Time, Love, and Care for 39th Avenue S

39th Avenue S between S Juneau Street and S Graham Street

Seattle Department of Transportation (SDOT) Review

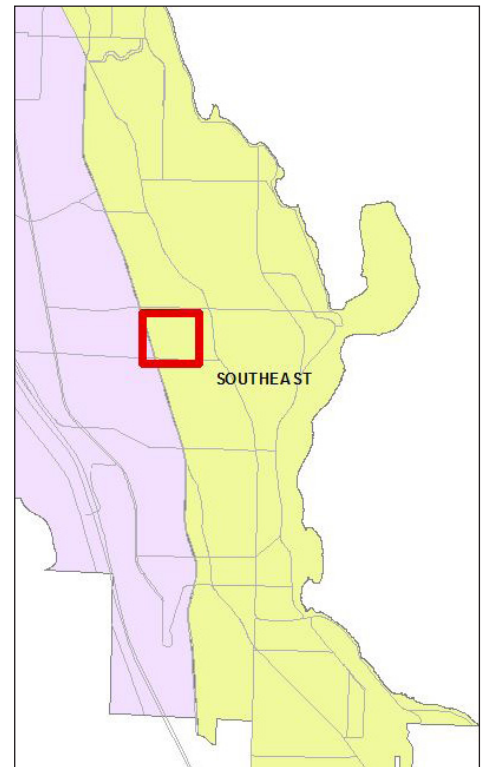
The majority of 39th Ave. S., between S. Juneau St. and S. Graham St., the sidewalks are worn and cracked due to repeated flooding and drainage issues. The problem is further worsened since there is no curb, many drivers park right on top of sidewalks without noticing the boundary between the street and sidewalk. Where the street ends and the sidewalks begins are deep, bumpy, cracked grooves in the pavement. The planting strips during the winter are pummeled into muddy craters by cars parked on them. When the cars try to leave, they are stuck in the mud, spinning their wheels creating a muddy mess.

Please repair cracked pavements, install proper curbs, and fix drainage issues.

During the conceptual design phase, SDOT worked with the applicant regarding the options for repairing the sidewalk on 39th Ave S and fixing existing drainage problems. The conceptual design that added new curb along the west side of the street would also have narrowed the street in order to create more effective planting areas between the street and the sidewalk. Due to the perceived impacts of narrowing the roadway, this design was not feasible.

The proposed improvements included in this conceptual design are repairing sidewalk in poor condition on the west side of 39th Ave S near S Juneau St, adding landings at the southwest and southeast corners of 39th Ave S and S Juneau St, and repairing various shoulder areas on the west side of 39th Ave S between S Juneau St and S Graham St.
